**Lewiston Public Works Advisory Commission  
REGULAR MEETING AGENDA  
August 28, 2025 - 12:00 PM  
Bell Building – Second Floor Conference Room – 215 D Street  
Lewiston, Idaho 83501**

<p><b>ITEM TITLE</b> Progress Update on PWAC Project #1 - City Standards Update</p>	<p><b>AGENDA NO.</b> V.A. <b>AGENDA DATE:</b> August 28, 2025</p>
<p><b>ITEM SUMMARY (Background, Discussion, Key Points, Recommendations, etc.)</b></p> <p>Public Works is pursuing an update to the City of Lewiston (COL) standard drawings and modifications to the Idaho Standards for Public Works Construction (ISPWC); J-U-B Engineers, Inc. ("J-U-B") was hired to review and make recommendations.</p> <p>The City Engineer introduced this item at the May 21, 2025 meeting and assigned the Public Works Advisory Commission (PWAC) to provide feedback on the standard drawings and modifications to the ISPWC by June 11th; the elected officers were assigned to review and finalize PWAC’s feedback by June 26th.</p> <p>On June 27th, the staff liaison provided PWAC’s feedback to the City Engineer for review. The City Engineer has made a number of revisions to the standards and specifications based on the Commission's feedback and hi

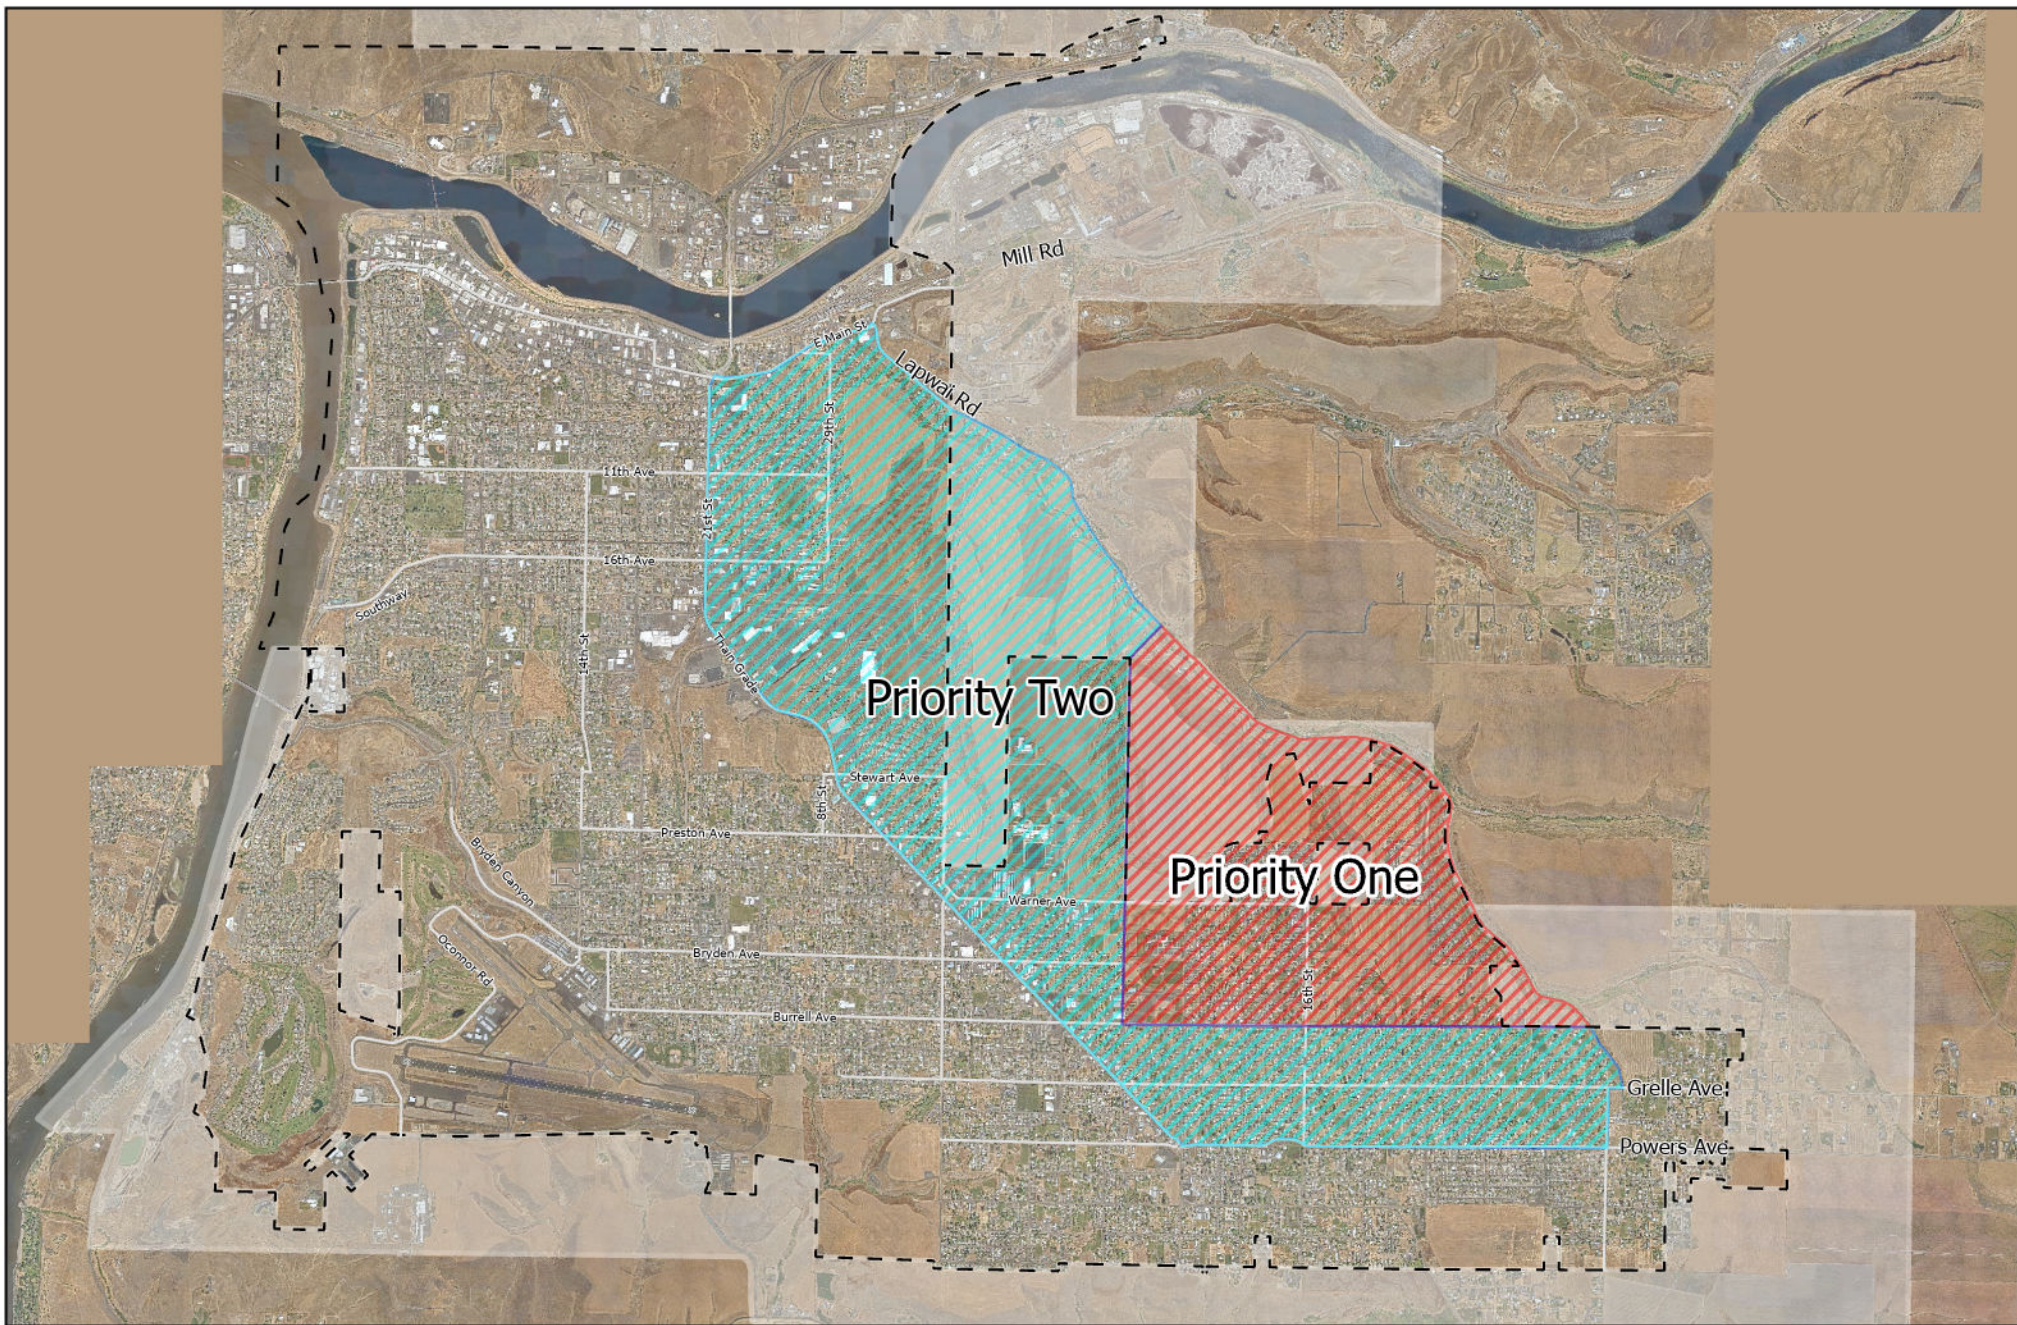
5-6	<a href="#">Concrete Manhole Collar</a>	Jan. '15				
5-7	<a href="#">Manhole Frame &amp; Cover</a>	Nov. '12			1) Double checking approval from PW Dept or PWD or City Engineer? 2) Note in #3 Grammatical - Shall be?	1) City Engineer. 2) Revised.
5-8	<a href="#">Manhole Channel Details</a>	Sept. '15
